Changes for SMD5 - SMD6:
need to move passives in ag1171 footprint area for ag1171 real module... touches caps.
bigger esp32 holes! they're a little tight

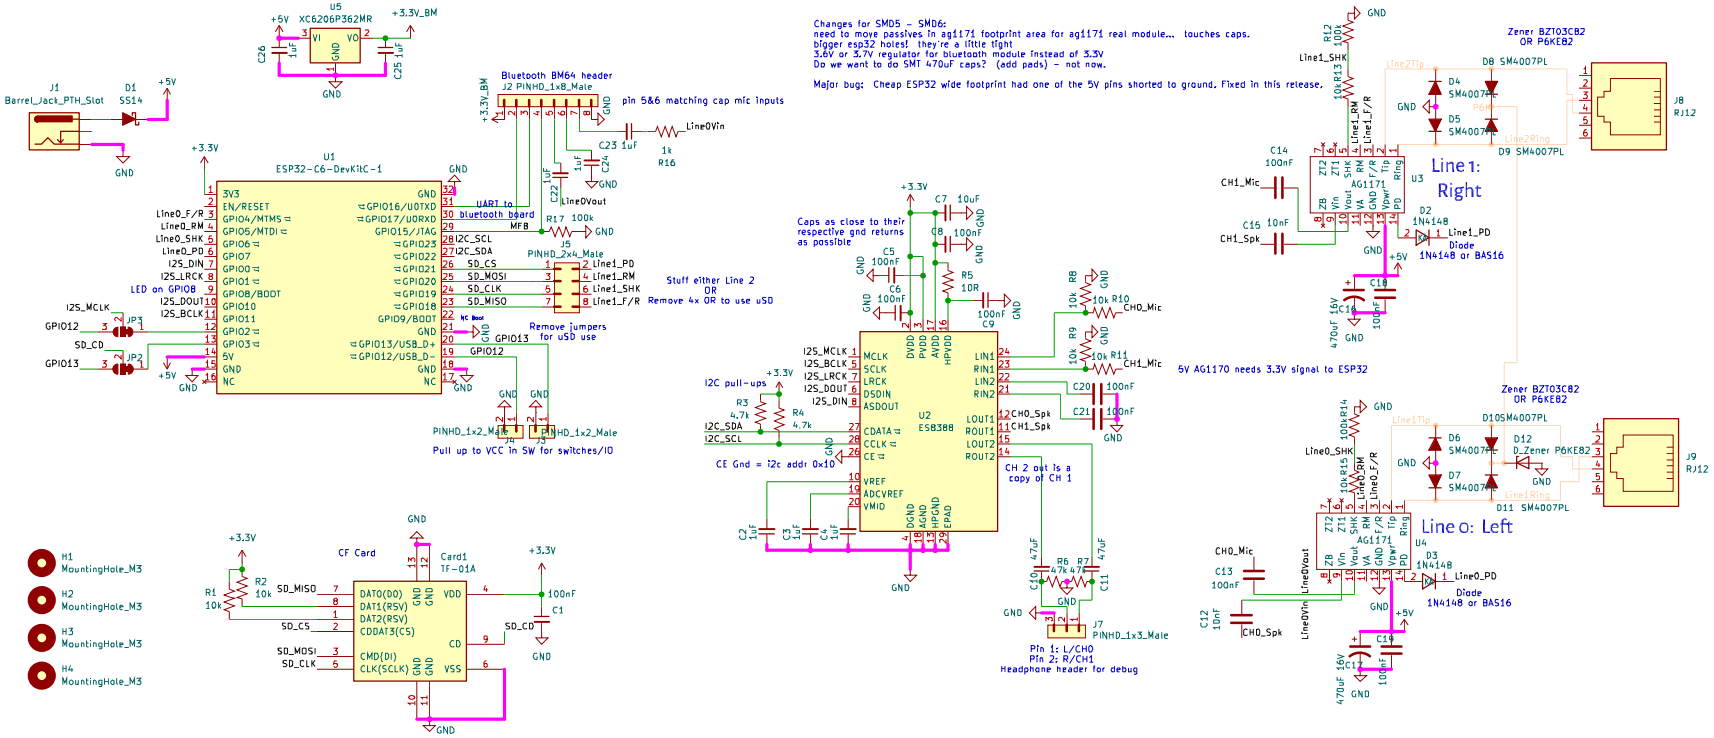
3.6V or 3.7V regulator for bluetooth module instead of 3.3V
Do we want to do SMT 470uF caps? (add pads) - not now.
Major bug: Cheap ESP32 wide footprint had one of the 5V pins shorted to ground. Fixed in this release.
Bluetooth BM64 header
J2 PINHD_1x8_Male
pin 5&6 matching cap mic inputs
UART to bluetooth board
MFB
PINHD_2x4_Male
Stuff either Line 2 OR Remove 4x OR to use uSD
Remove jumpers for uSD use
Pull up to VCC in SW for switches/IO
LED on GPIO8
Caps as close to their respective gnd returns as possible
I2C pull-ups
CE Gnd = I2c addr 0x10
CH 2 out is a copy of CH 1
Headphone header for debug
Pin 1: L/CH0
Pin 2: R/CH1
5V AG1170 needs 3.3V signal to ESP32
Zener BZT03CB2 OR P6KE82
Line 1: Right
Line 0: Left
Diode 1N4148 or BAS16
CF Card
ESP32-C6-DevKitC-1
ES8388
AG1171
